General Comments on the Portland Harbor Feasibility Study By Environmental Stewardship Concepts, LLC For the Willamette Riverkeeper and the Portland Harbor CAG July 27, 2012

General Comments:

Figure 1. Minimum, mean, and maximum monthly Willamette River stage at Portland, Oregon from years 1973 through 2003. (US Army Corps of Engineers).

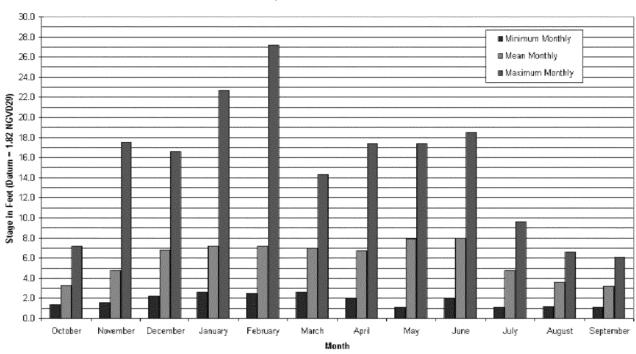
- 1. **Section 1.0** (Introduction) states that, *The exact boundaries of the [Portland Harbor] Site have not yet been defined by EPA, which will do so in the Proposed Plan*A Why are the exact boundaries not determined yet? What is keeping this delineation from occurring at this stage?
- 2. **Section 2.1.1** (Hydrology) states that, *River stage and currents at the Site are influenced by hydrologic conditions in both the Willamette and Columbia Rivers, and are further affected by the operations of federal and non-federal dams along these two rivers, as well as tidal stages of the Pacific Ocean, which causes tidal fluctuations of up to a maximum of 3 feet per day throughout the SiteA*
 - Relative to the tide difference, there is more than a 3 foot tidal fluctuation. Is the three feet only referencing the influence of the ocean tides on the fluctuations

seen at Portland Harbor? USGS tides recorded at Morris Street Bridge show that an average tidal fluctuation in a day would not likely average to 3 feet.

Figure 2. Willamette River stage at Portland Oregon, from October 1, 1988 to June 8, 2012 (USGS)

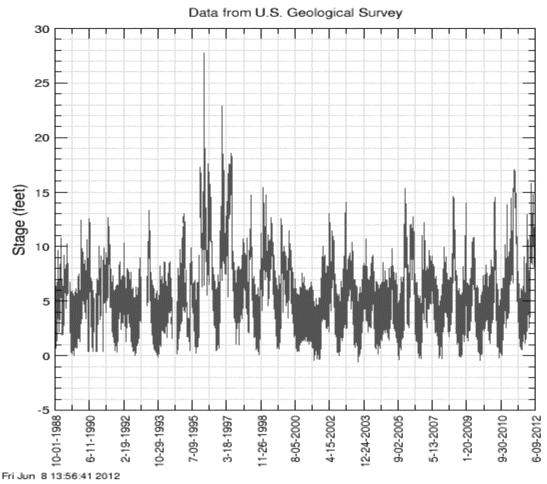
3. **Section 2.1.1** references past extreme flood events: The two highest peaks in the daily mean discharge record occurred during the winters of 1996 and 1997, when peak flows reached 420,000 cfs on February 9, 1996 and 293,000 cfs on r) J 9) I T T P 9))) g))) e) Columbia River, the Willamette River flows generally increase in response to regional storms due to the comparatively small size of the basin. Record winter floods (e.g., 1964 and 1996) occurred when periods of heavy snowfall at lower elevations were followed by warming periods and heavy rains, resulting in rapid increases in runoffA

Have the alternatives been examined under conditions **more extreme** than these flood events? Any models using flow and river stage should incorporate the increasing occurrence and frequency of these events, as they are more likely a result of global warming. The following graph shows the Willamette River stage at Portland Oregon and the floods of 1996 and 1997.
